| Date 13.06.03 | Ref. No. 03AH003 | Model AM-LM918, LCX-MT22, XR-FD1, XR-FD5, XR-V10MD | HA |
| Subject "Disc Error" Indication | | | IRIS C625 |

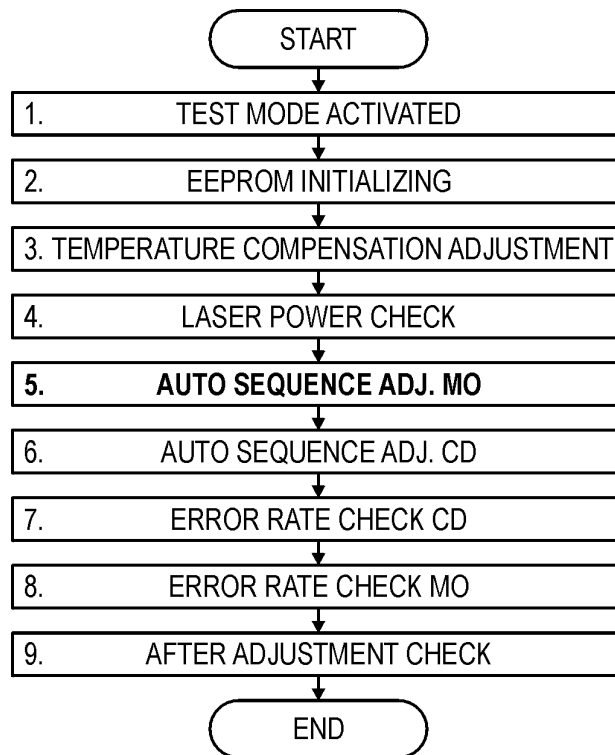
"Disc Error" may be displayed with specific discs such as Sony MD (Neige series), i.e. 5MD74NEA, 5MD80NEA, 10MD74NEA, 10MD80NEA.

Unstable reading when using low-reflectivity MO discs.

Using the test disc "**MDW-74/AU1**" (8-892-341-41), only perform the "Auto Sequence Adj. MO" (step 5 of the "Adjustment Procedure Flowchart" below).

If the message "Failed" appears during the adjustment, perform the complete adjustment procedure as described in the Service Manual.
